ARIZONA DEPARTMENT OF ENVIRONMENTAL QUALITY

RE: 2015 Revision to the Arizona State Implementation Plan for Regional Haze

Revision to the Arizona Regional Haze Plan for Arizona Public Service Cholla Generating Station

Figure 3 Cumulative NOx Emissions Associated with EPA's FIP vs. Cholla BART Reassessment over 2016-2046

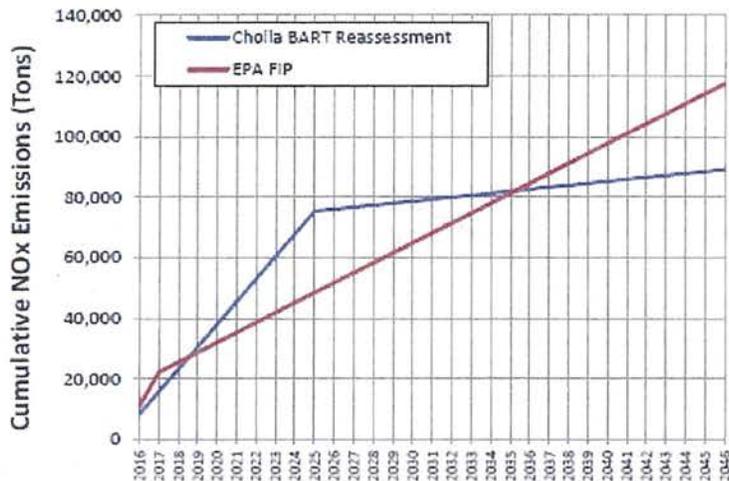
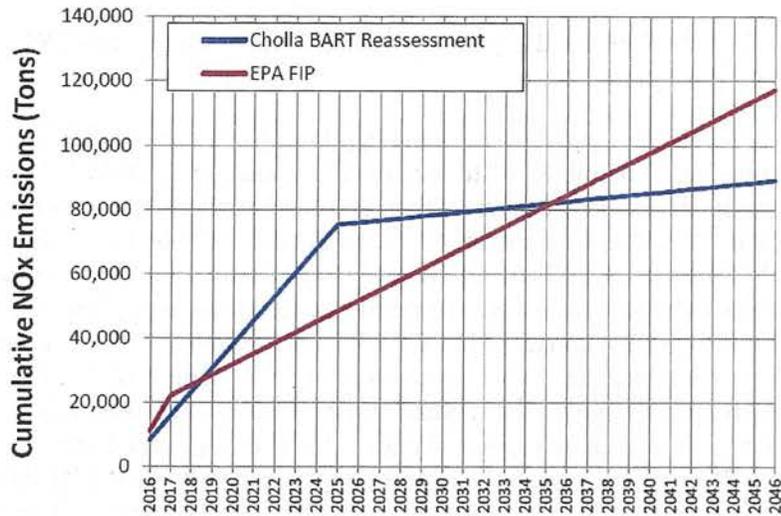
First, the record shows the Cholla BART “reassessment” would increase Cholla’s NOx pollution compared to the existing BART determination.¹⁴ Under the BART “reassessment,” between 2018 and 2025, Cholla would emit *4,161 tons per year more NOx pollution* than it would under the existing BART determination.¹⁵ In addition, the BART “reassessment” would result in greater cumulative NOx pollution for eighteen years after the BART compliance deadline.¹⁶ Figure 3 from ADEQ’s proposal illustrates how the BART “reassessment” would increase Cholla’s NOx pollution by allowing Units 3 and 4 to continue operating for the next ten years without installing additional pollution controls.¹⁷

As shown in Figure 5 of the Draft SIP Revision, higher NO_x emissions from 2018–2025 under the APS BART Proposal will result in higher visibility impacts at affected Class I areas than under the EPA FIP.

Figure 6 Comparison of Integrated Visibility Impacts at Petrified Forest National Park Associated with EPA FIP vs. Cholla BART Reassessment

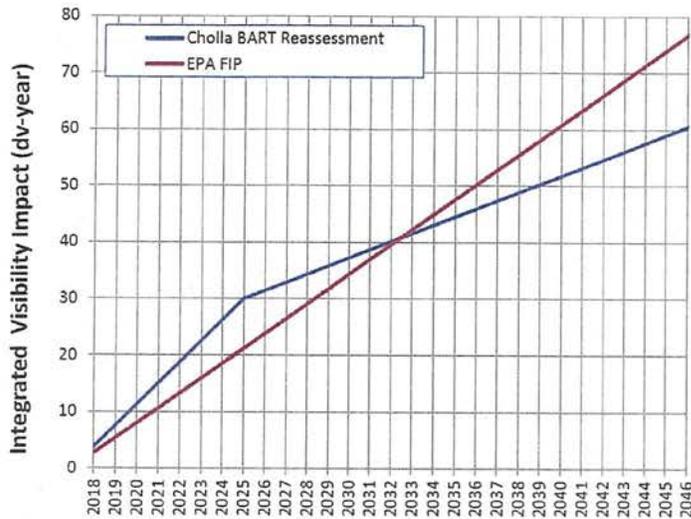
As the Ninth Circuit recently stated, it would not be “difficult[.]” to show a section 110(l) violation if an existing implementation plan unambiguously required a certain level of pollution reductions, and a plan revision would result in more pollution. *El Comite Para el Bienestar de Earlimart*, 786 F.3d at 696 (“The difficulty with [the] argument” that a revision weakened an existing plan’s 20% pollution reduction requirement, is that the existing plan “is ambiguous, because it refers to both a 12% reduction and a 20% reduction.”). But this is exactly what would occur under the BART “reassessment,” as Arizona’s new BART determination would result in an additional 4,161 tpy of NOx pollution for more than seven years after the BART compliance deadline. Moreover, when Cholla’s cumulative NOx emissions are considered, the BART “reassessment” would result in increased pollution levels until 2035, which is nearly two decades after the BART deadline.

Figure E-2: Plot of Predicted Cumulative Visibility Impacts at Grand Canyon National Park Associated with EPA FIP (red) vs. Proposed BART Reassessment (blue)

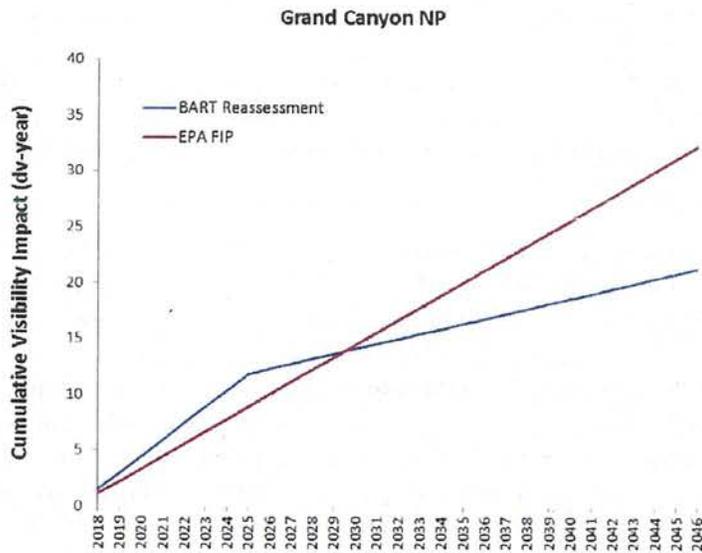
The situation is similar at the Grand Canyon. As Figure E-2 to ADEQ’s proposal shows, Cholla’s visibility impacts at the Grand Canyon would be worse under the BART “reassessment” for twelve years after the BART compliance deadline.²⁰ Furthermore, ADEQ acknowledges that this same “general pattern” of worse visibility impacts under the reassessment holds true at the other Class I areas impacted by Cholla’s air pollution.²¹

Figure 1 Cumulative PM₁₀ Emissions Associated with 2011 AZ SIP vs. Cholla BART Reassessment over 2016-2046

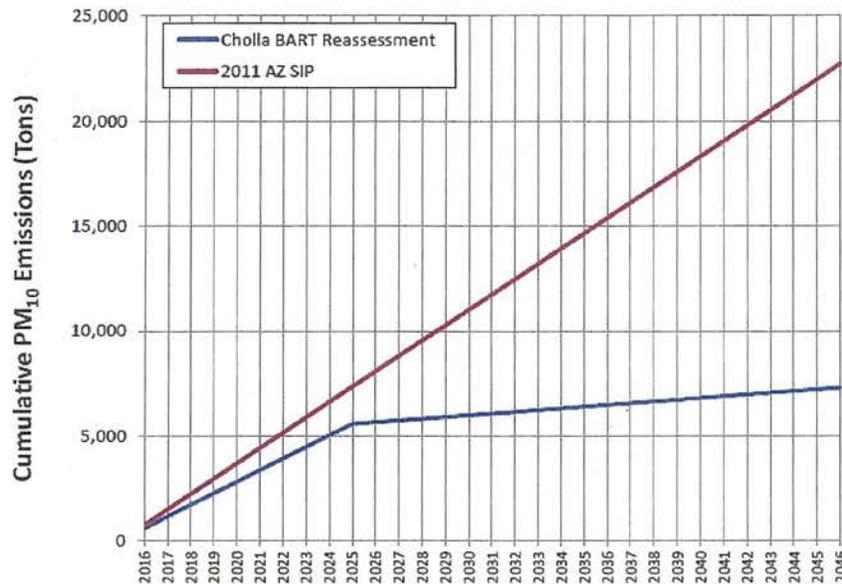
Overall, the APS BART Proposal will decrease PM₁₀ emissions by about 15,000 tons by 2046 as compared with the applicable 2011 Arizona SIP.²³ Figure 1 of the Draft SIP Revision compares the cumulative PM₁₀ emissions under the 2011 Arizona SIP and the APS BART Proposal.

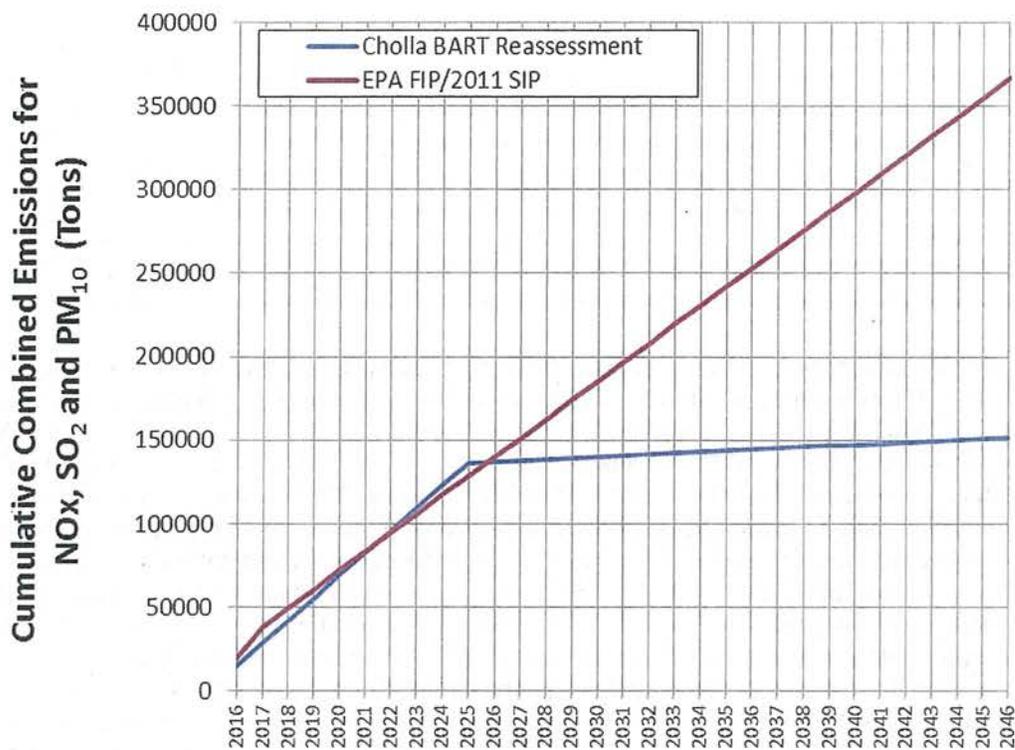
Comment: One commenter stated that the BART Reassessment weakens Cholla's existing BART determination from the EPA FIP in violation of the Clean Air Act's anti-backsliding provision. The commenter pointed out that the BART Reassessment would result in greater air pollution and worse visibility impairment at Class I areas for nearly two decades after the BART compliance deadline. The commenter asserted that the existing BART determination is an "applicable requirement" under Clean Air Act Section 110(l), and any revisions resulting in greater air pollution and worse visibility impairment are contrary to the Clean Air Act's anti-backsliding provision.

Response: ADEQ disagrees with this comment. In EPA's review of a proposed BART FIP replacement SIP in Oklahoma where the state determined that the shutdown of one unit in 2016 and a second unit in 2026 was BART in light of the utility's decision to permanently retire those units (*i.e.*, due to the changed circumstances giving rise to BART reanalysis), EPA stated that "[s]uch a SIP revision need not adopt the same suite of control options and techniques as EPA's FIP, nor does it necessarily have to be as stringent as EPA's FIP in all instances." 78 Fed. Reg. 51,686, 51,691 (Aug. 21, 2013). EPA then applied Section 110(l) in the regional haze context, stating "EPA must approve a State's SIP revision so long as the State complies with the CAA's visibility protection provisions, the RHR, and the BART Guidelines, and makes a reasonable control determination based on the weighing of the five factors." *Id.* EPA explained that the "controlling facts" (*i.e.*, shutdown of the two units) for Oklahoma's revised BART analysis were different from the facts that were presented with the state's earlier SIP submission and, as a result, "the high incremental cost-effectiveness and low incremental visibility improvement" between the FIP and the shutdown scenario support the conclusion that the shutdown option is BART. *Id.* at 51,691-92. EPA thus proposed to approve the Oklahoma SIP even though it did not achieve the same level of visibility control throughout the period as did the FIP. *Id.* at 51,692. EPA confirmed this decision in the final rule. 79 Fed. Reg. 12,944 (Mar. 7, 2014). Thus, the commenter's insistence that Section 110(l) demands that the SIP must have, for a given time period, the same or lower emissions or the same or better visibility impact is misplaced.
